Solicitation Amendment No. 001

To:	Date:
Prospective Proposers:	March 29, 2012
Project Title:	Project No.:
Southeast Campus Infrastructure Improvements	12-32

**Southeast Campus Parking Infrastructure Improvements
Project # 12-32**

Addendum #2 - 04-04-2012

04 DUMPSTER GATE HINGE
1/8" = 1'

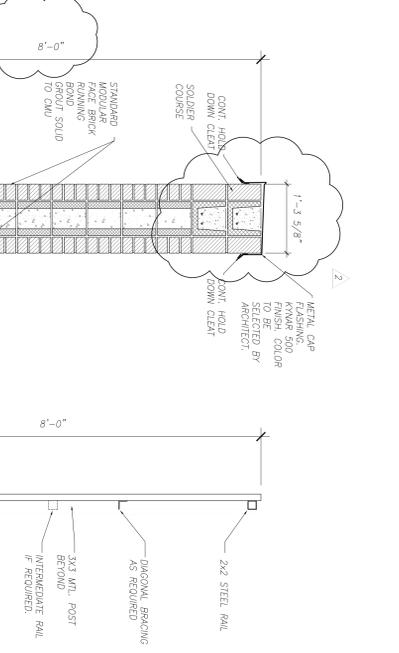
- ii. New 35' driveway added for street access to revised dumpster enclosure. See attached City of Houston Driveway construction detail
 - iii. Gate Hinge detail moved to detail designation 04

02 BOLLARD DETAILS
3/8\" = 1'

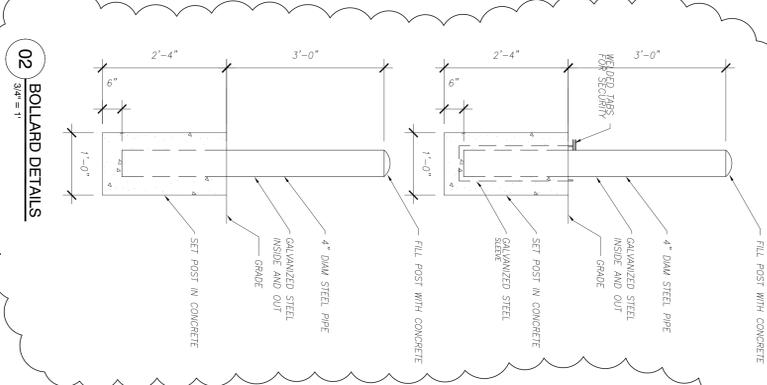
- ix. Ten (10) 6 inch steel bollards added to scope. Two of the bollards should be removable to accommodate enclosure door swing. Re: detail 02
- c. Drawing Sheet AS6.06

11 TYPICAL FENCE ELEVATION WITH SLATS
1/4\" = 1'

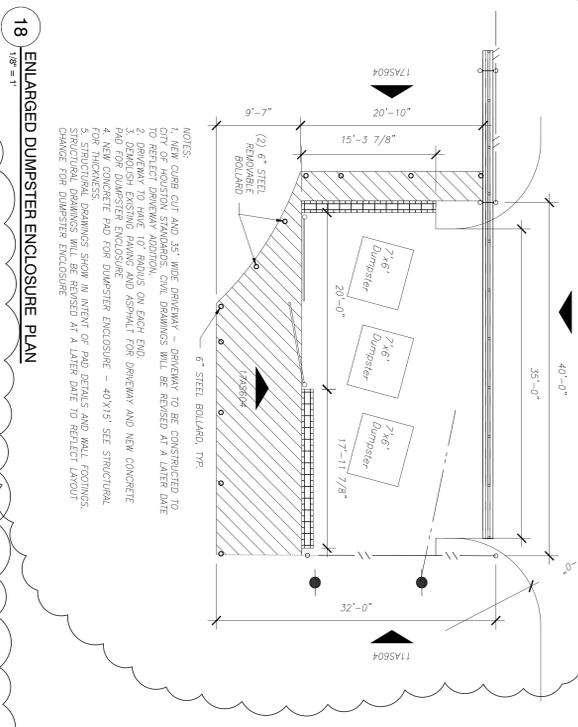
- vi. Slatted fence elevation detail added.
 - vii. Detail 17 revised to reflect elevations of new dumpster enclosure layout.
 - viii. Additional 7 foot height chain link fence added.

18 ENLARGED DUMPSTER ENCLOSURE PLAN
1/8\" = 1'

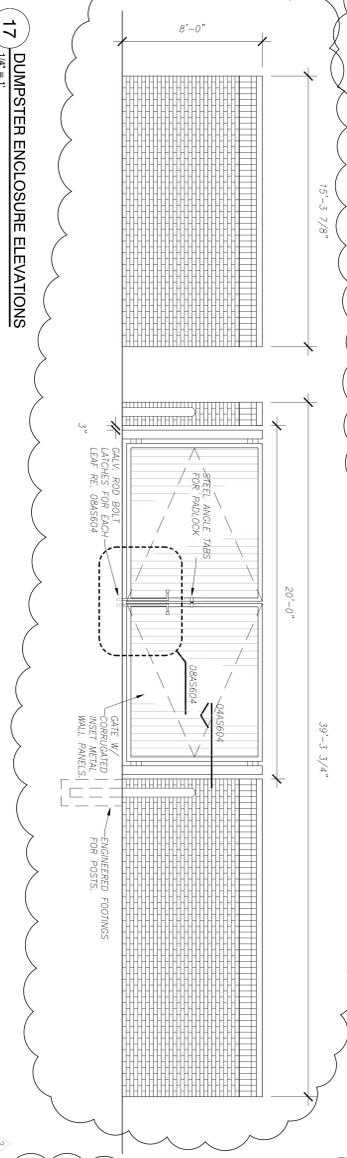
- b. Drawing Sheet AS6.04
 - i. Dumpster enclosure layout has been revised. Structural drawings show the design intent of the foundation for the slab and walls. The structural drawings will be revised at a later date to reflect the new layout. The slab size for the new layout is 40'x15'. Masonry walls are no longer 10 feet in height and have been reduced to 8 feet.

- iv. Dumpster enclosure masonry wall is now 8 foot in height.
 - v. New rolling gate added to scope. Gate to have 40 foot clear opening. Chain link specification revised to include gate information.

12 FLAG POLE RELOCATION PLAN - NORTHWEST CORNER OF GARLAND ST AND RUSTIC ST.

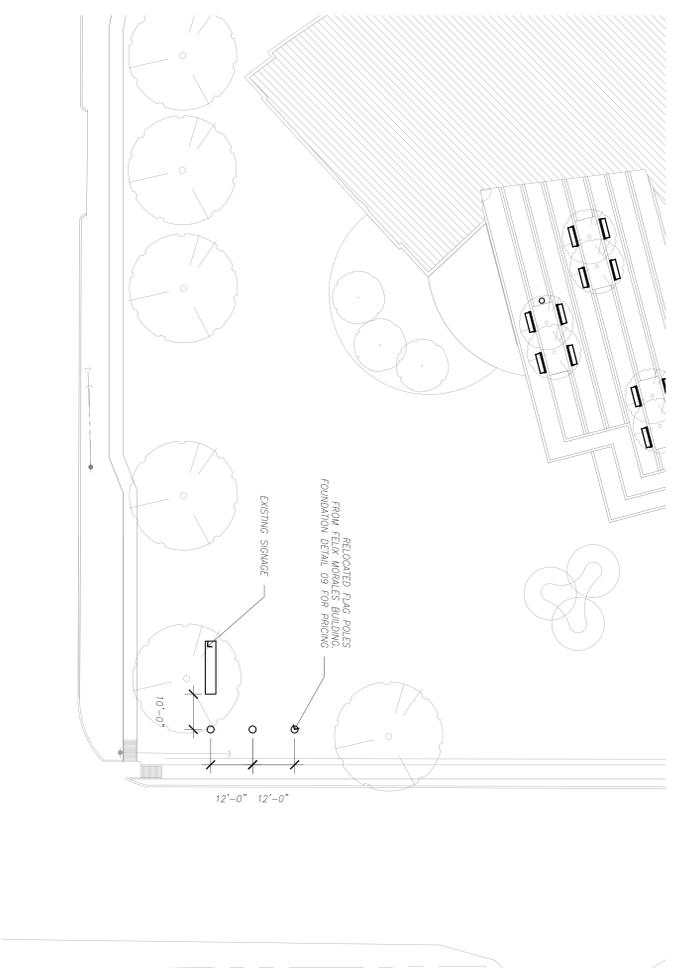
- i. Sheet added for pricing only.
 - ii. Sheet includes foundation details for site lighting and foundations for flag poles.
 - iii. Sheet includes location plan for flag poles to be relocated from the Felix Morales Building.
